## **BCA CAPABILITY REPORT**

## **Combined Projects (Westmead)**

Lot 4 WSU 2A Darcy ROAD, **WESTMEAD NSW 2145**

Our Ref: J160221

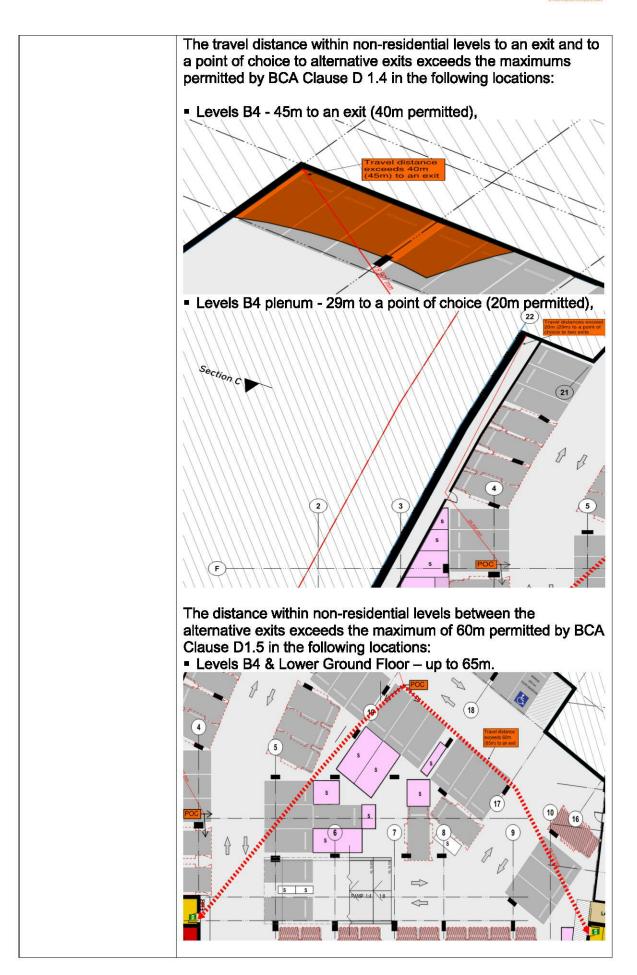
# ltem Comment Number of exits Two exits are required from each storey by BCA Clause D1. 2 as required the building has an effective height greater than 25m. E2 Level 8 RL 57.350 COMS = The single exit on Block E2 level 2 cannot be supported by VLP as the building has an effective height of >50m and two exits are required for all areas. It has been noted that roof top plant rooms which have access to a single exit only. 18050 D2 Roof TOP OF PLANT RL 55.950 Note: The client has advised that they will be undertaking a fire engineered alternative solution for any compliance in relation to the number of exits required in BCA Clause D1.2.

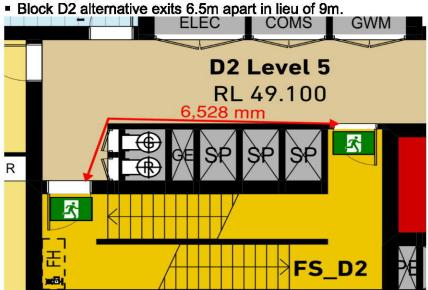
Exit travel distances and distance between exits The distance of travel from the apartments to an exit or point of choice between alternative exits exceeds the maximum of 6m permitted by BCA Clause D1.4 in the following areas:

Note: The client has advised that they will be undertaking a fire engineered alternative solution for any compliance in relation to the travel distances required in BCA Clause D1.4.

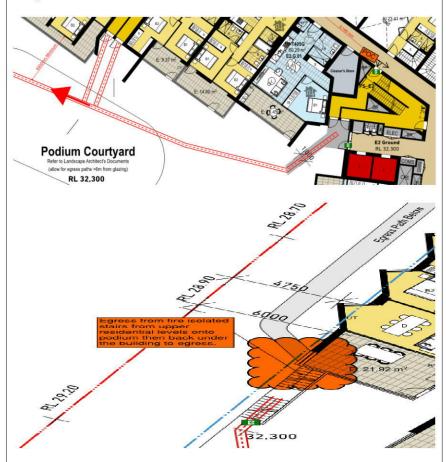
Discharge from the fire-isolated stairways serving the residential storeys does not comply with the Prescriptive Requirements of BCA Clause D1.7(b).

Fire isolated stairs F & E2 discharge onto the Ground floor podium courtyard, and then have to pass under the building again (along GL22 – T) prior to discharging along the egress path located on the setback.

Note: The client has advised that they will be undertaking a fire engineered alternative solution for the non-compliant exit discharges.
